DOCUMENT CHANGE REQUEST

DCR number 121	Changes required for: General	Originator: S Thacker
Date: 2004/06/04	Date sent: 2004/06/04	Organisation: ESA/ESTEC
Status: IMPLEMENTED

Title:	CMOS Analogue Multiplexer/Demultiplexer (Triple 2-Channel), based on type 4053B		
Number:	9202/049	Issue:	1

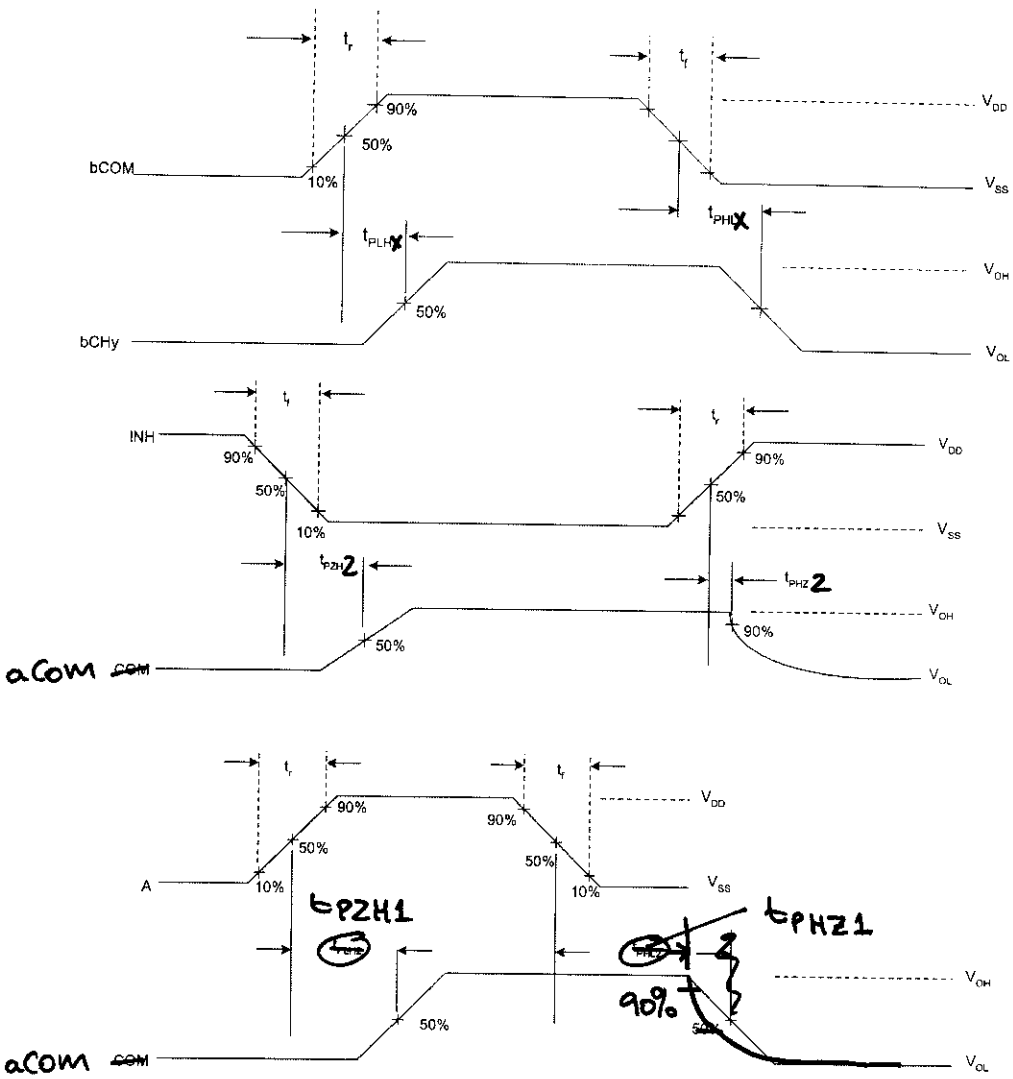
3) Electrical Test table & circuit (Table 2/Fig 4(p) (para 2.3.1/2.3.3 note 8)) - parameters: Propagation times.
Test conditions for channel inputs for tPLH2 (=tPZH1), tPLH3 (=tPZH2), tPHL2 (=tPHZ1), tPHL3 (=tPHZ2) have been amended/clarifed for correct switching. The switching waveforms have also been corrected in Fig 4(p)(para 2.3.3 note 8).
- see attached sheets for current and new table & fig/note.

Characteristics	Symbols	MIL-STD-883 Test Method	Test Conditions Note 1	Limits		Units
				Min	Max	
Propagation Delay Low to High X bCOM to bCHy	t_{PLH}X	3003	V_{IN}(COM)=Pulse Generator V_{IN} (Remaining Inputs)=Truth Table V_{IL}=0V, V_{IH}=5V, R_L=200kΩ V_{DD}=5V, V_{SS}=V_{EE}=0V Note 8	-	40	ns
Propagation Delay High to Low X bCOM to bCHy	t_{PHL}X	3003	V_{IN}(COM)=Pulse Generator V_{IN} (Remaining Inputs)=Truth Table V_{IL}=0V, V_{IH}=5V, R_L=200kΩ V_{DD}=5V, V_{SS}=V_{EE}=0V Note 8	-	40	ns
~~Propagation Delay Low to High~~ 2, A to aCOM (~~Channels ON~~)	~~t_{PLH}~~ 2 t_{PZH1}	3003	V_{IN}(A)=Pulse Generator V_{IN} (Remaining Inputs)=Truth Table V_{IL}=0V, V_{IH}=5V, V_{IN}(CH)=~~0V and~~ 5V and Open R_L=10kΩ V_{DD}=5V, V_{SS}=V_{EE}=0V Note 8	-	670	ns
~~Propagation Delay High to Low~~ 2, A to aCOM (~~Channels ON~~)	~~t_{PHL}~~ 2 t_{PHZ1}	3003	V_{IN}(A)=Pulse Generator V_{IN} (Remaining Inputs)=Truth Table V_{IL}=0V, V_{IH}=5V, V_{IN}(CH)=~~0V and~~ 5V and Open R_L=10kΩ V_{DD}=5V, V_{SS}=V_{EE}=0V Note 8	-	670	ns

Output Enable Time High Impedance to High Output 2, INH to aCOM	t_{PZH}2	3003	V_{IN}(INH)=Pulse Generator V_{IN} (Remaining Inputs)=Truth Table V_{IL}=0V, V_{IH}=5V, V_{IN}(CH)=5V, R_L=10kΩ V_{DD}=5V, V_{SS}=V_{EE}=0V Note 8	-	400	ns

Characteristics	Symbols	MIL-STD-883 Test Method	Test Conditions Note 1	Limits		Units
				Min	Max	
Output Disable Time High Output to High Impedance 2, INH to aCOM	t_{PHZ} 2	3003	V_{IN}(INH)=Pulse Generator V_{IN} (Remaining Inputs)=Truth Table V_{IL}=0V, V_{IH}=5V, V_{IN}(CH)=5V, R_L=300Ω V_{DD}=5V, V_{SS}=V_{EE}=0V Note 8	-	400	ns
